**Subject: Palmdale Hybrid Power Project – Docket 08-AFC-9
City of Palmdale’s Supplemental Information and Comments on the
Preliminary Staff Assessment for the Palmdale Hybrid Power Project**

**CITY OF PALMDALE'S SUPPLEMENTAL INFORMATION AND COMMENTS
ON THE PRELIMINARY STAFF ASSESSMENT FOR THE
PALMDALE HYBRID POWER PROJECT**

Biological Resources
Attachment BR-3
Revised PHPP Vegetation Maps

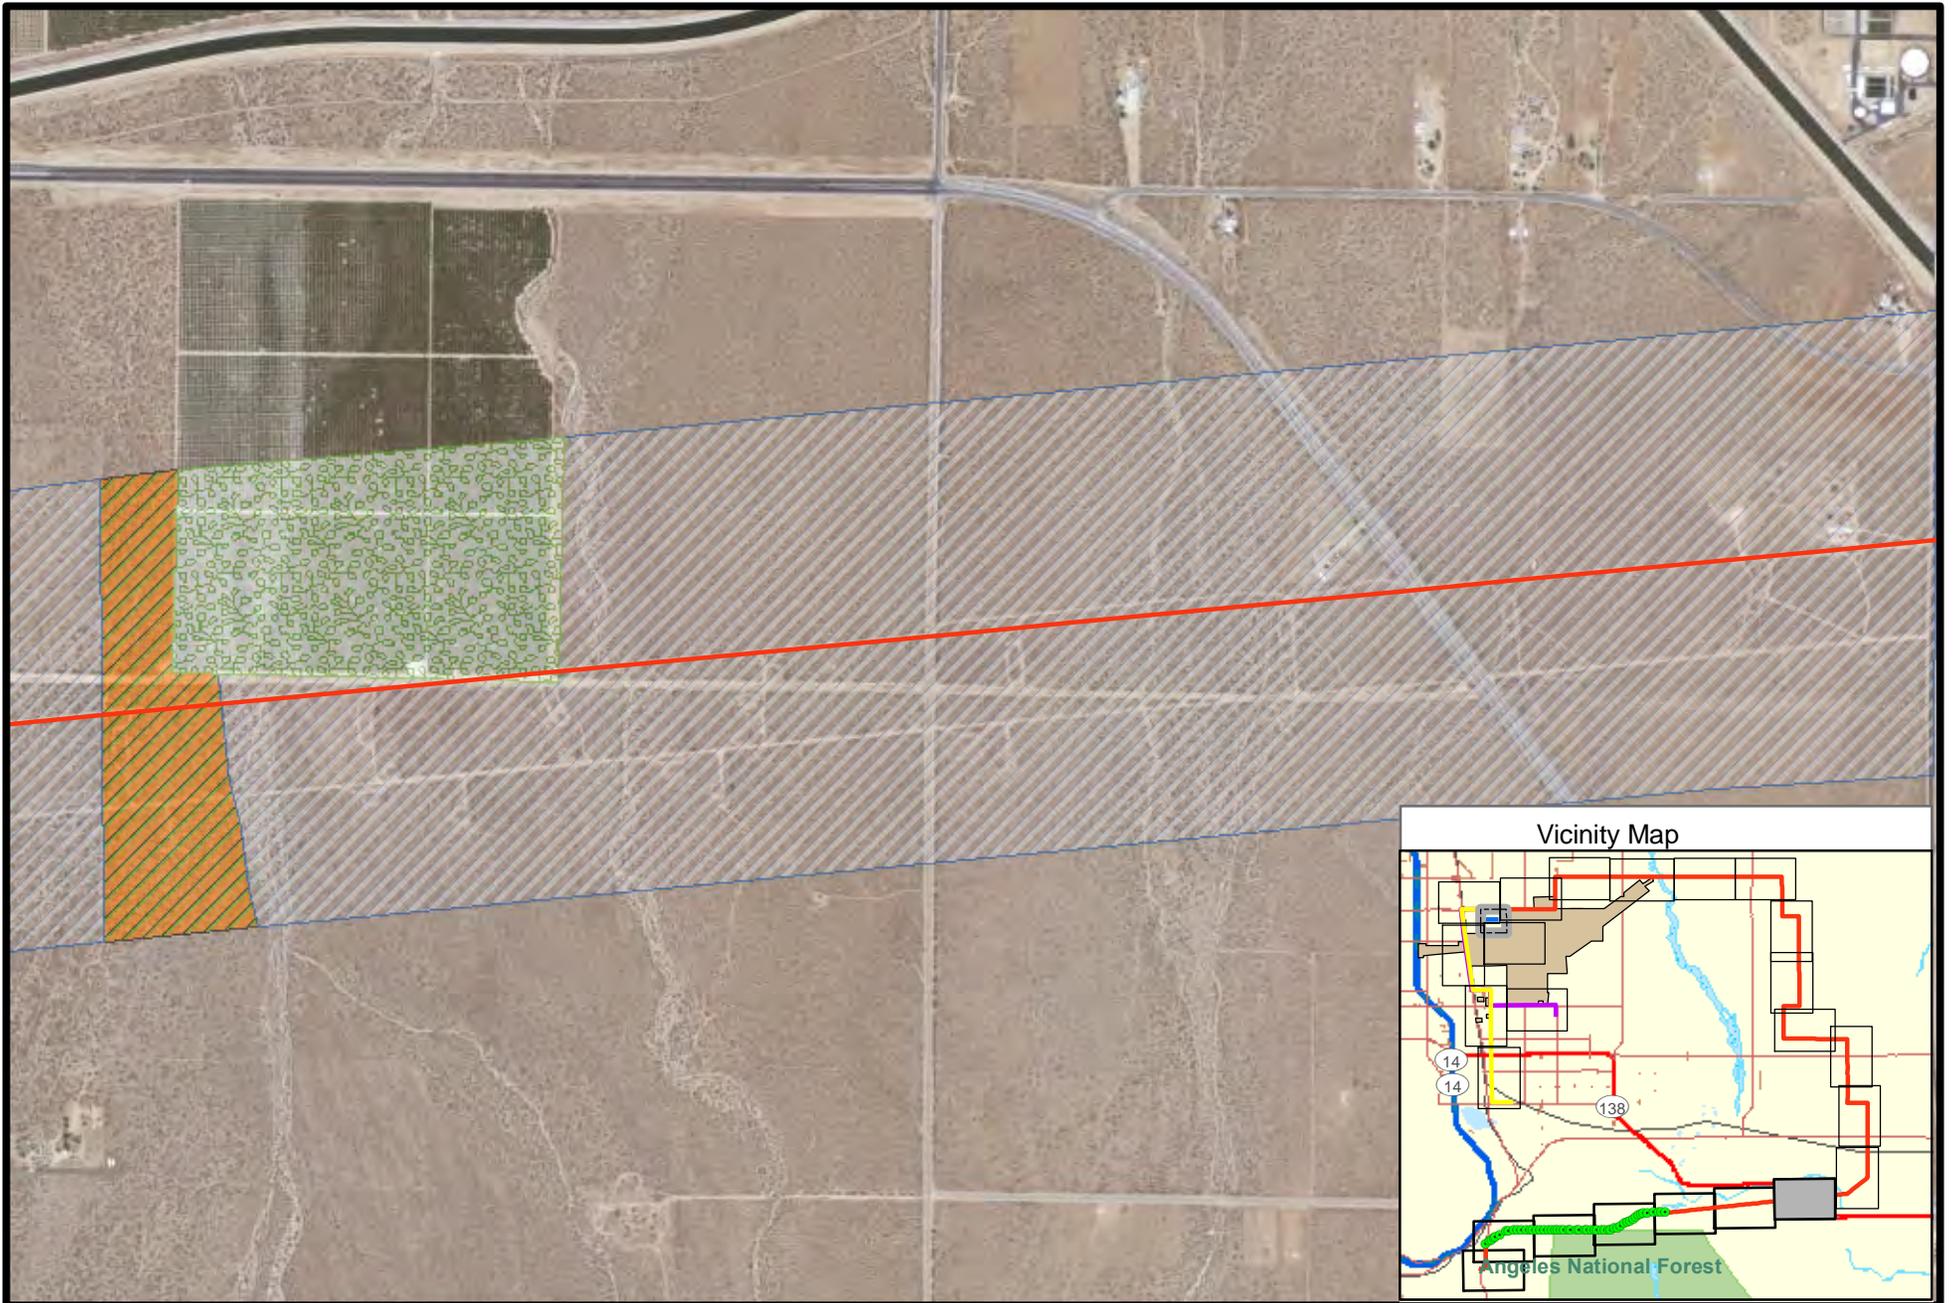
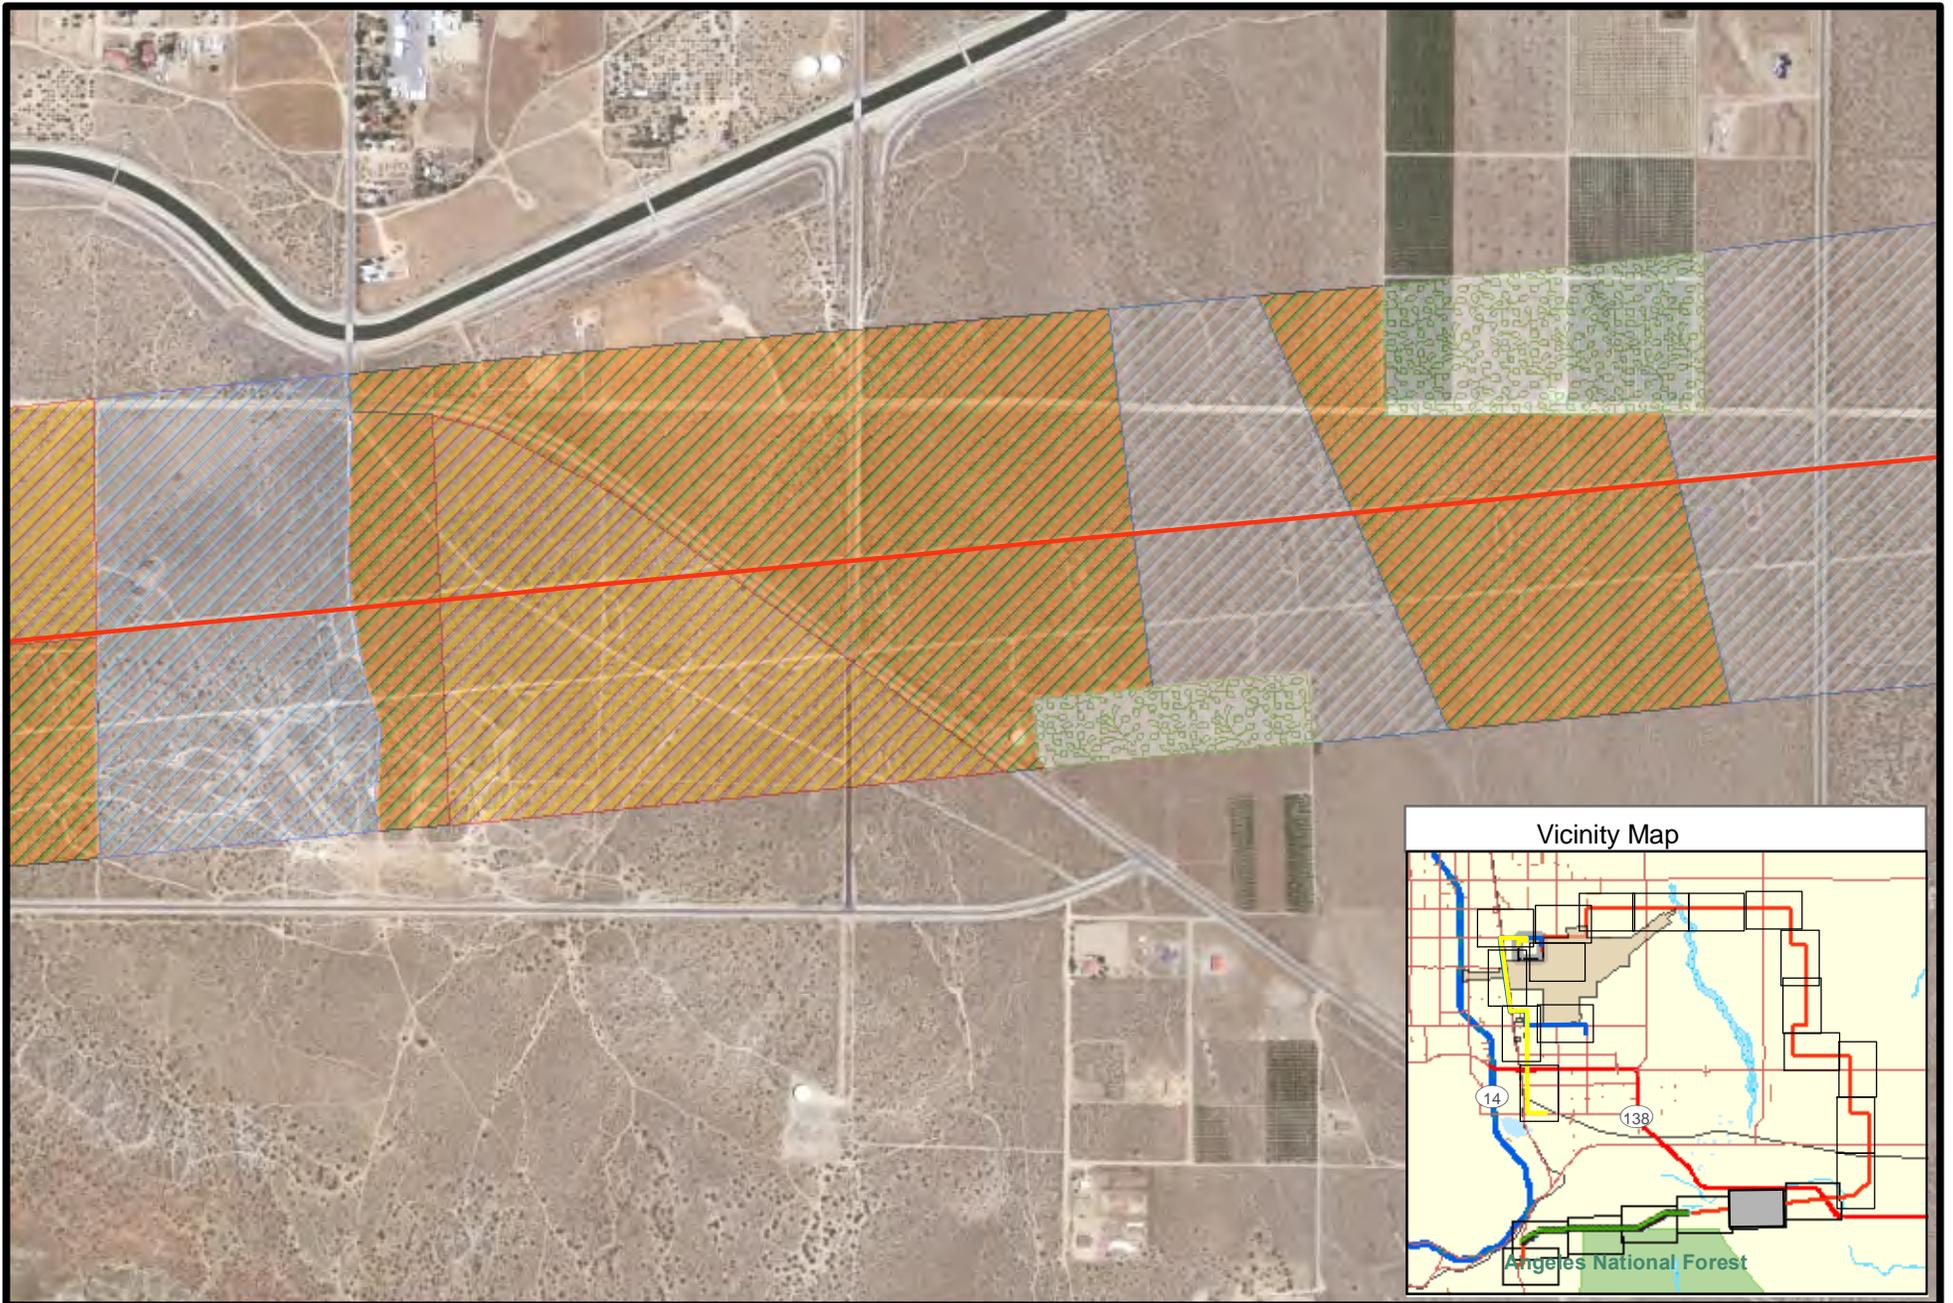
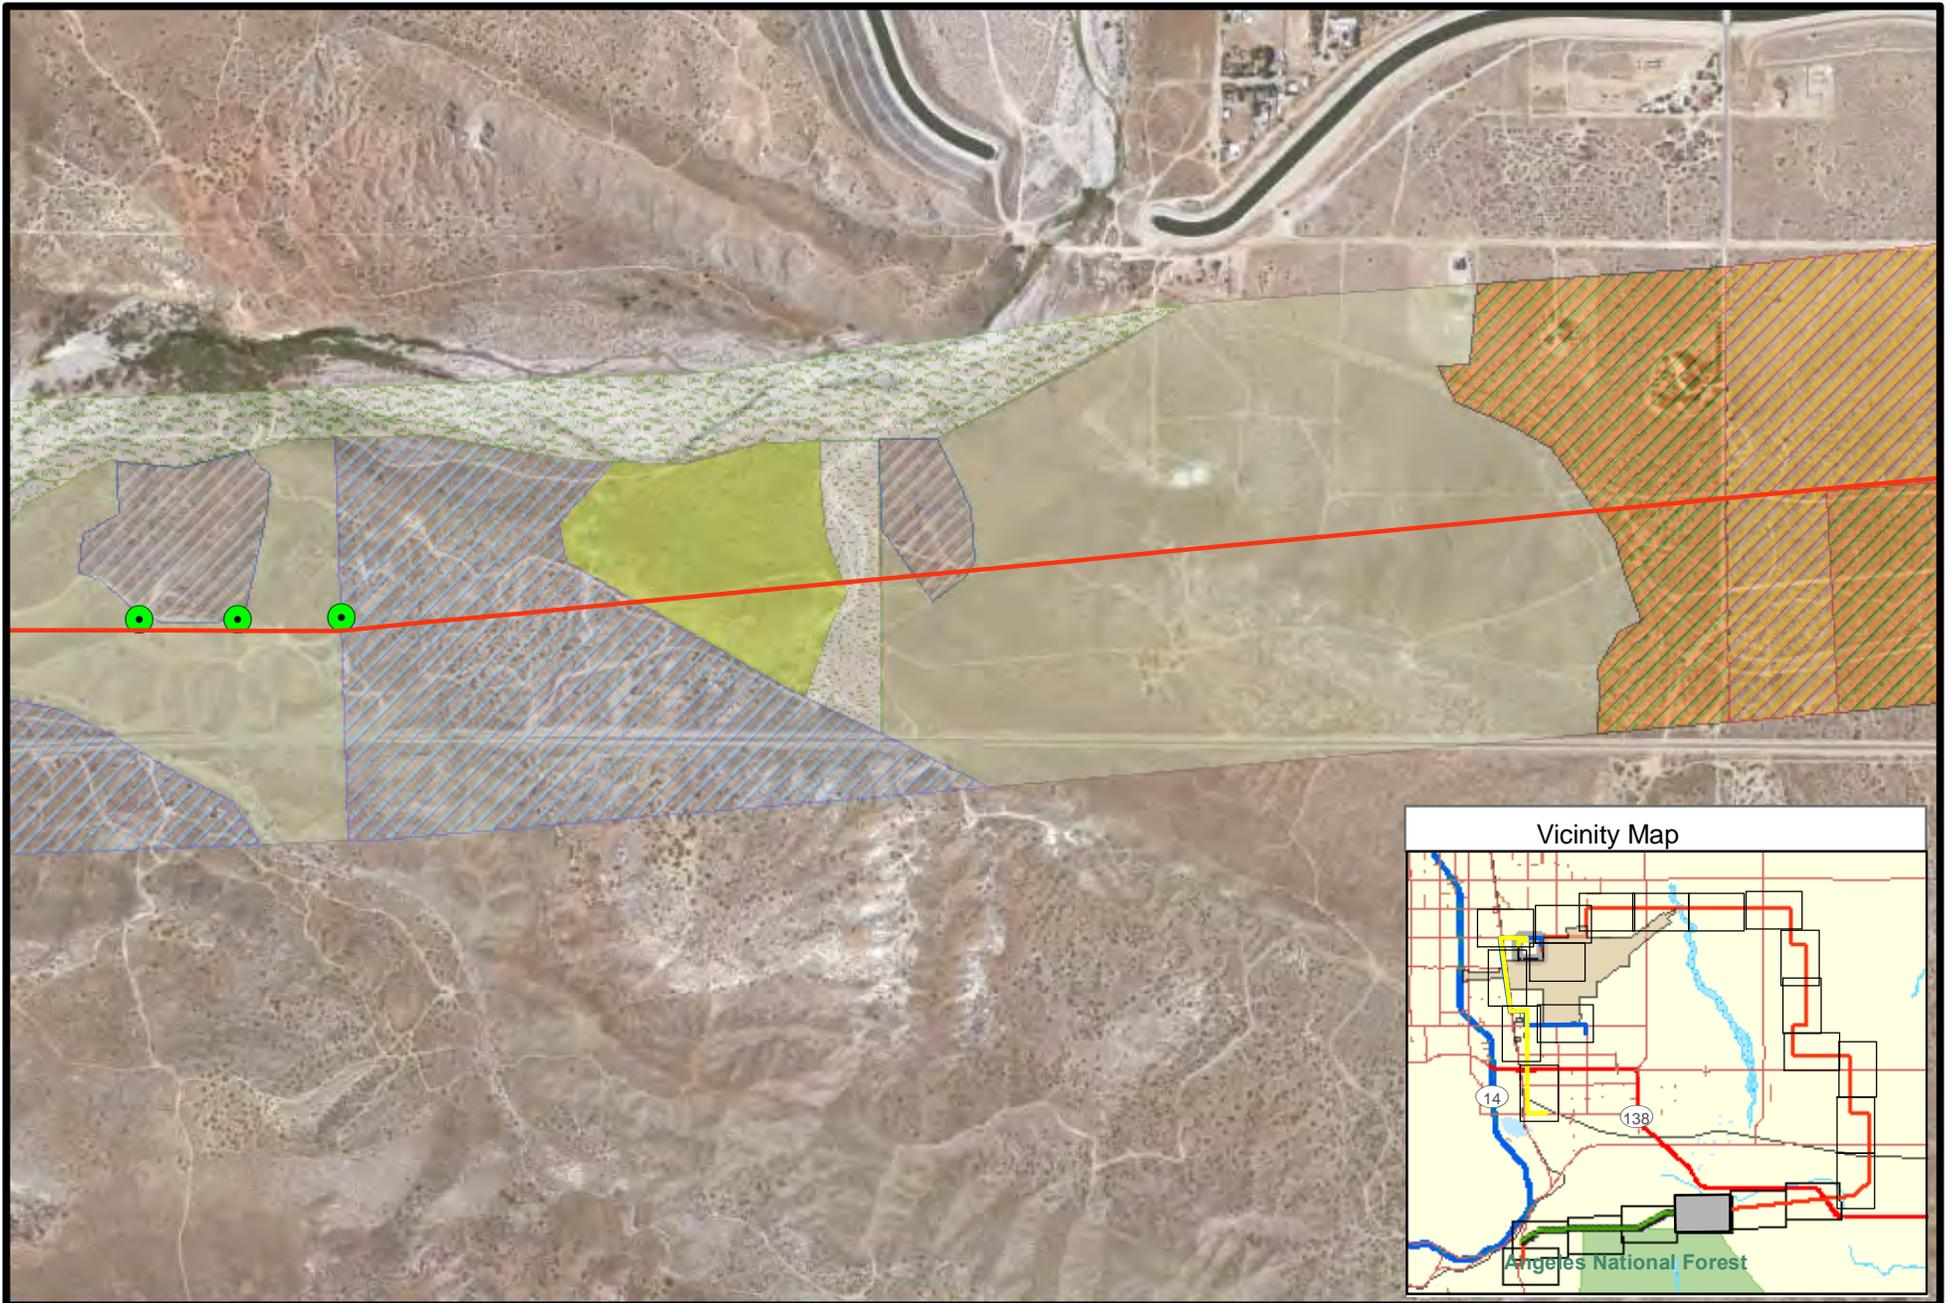
2. Revised Vegetation Mapping

One of the Applicant's consultants (AMEC Earth and Environmental) reviewed the vegetation mapping that had been provided in the AFC (Appendix H, Figure 6). Based on this review, it was concluded that no changes were needed to the vegetation mapping of the power plant site, reclaimed water pipeline or Segment 1 of the transmission line. However, some refinement of the mapping along Segment 2 of the transmission line was needed. The revised vegetation maps along this portion of the Project are provided in Attachment BR-3. The revisions to the mapping result in changes to the number of acres of the vegetative communities by the PHPP as shown in the Revised AFC Table 5.3-6R below. The changes are a combination of the new vegetation mapping as well as further refinements in project design.
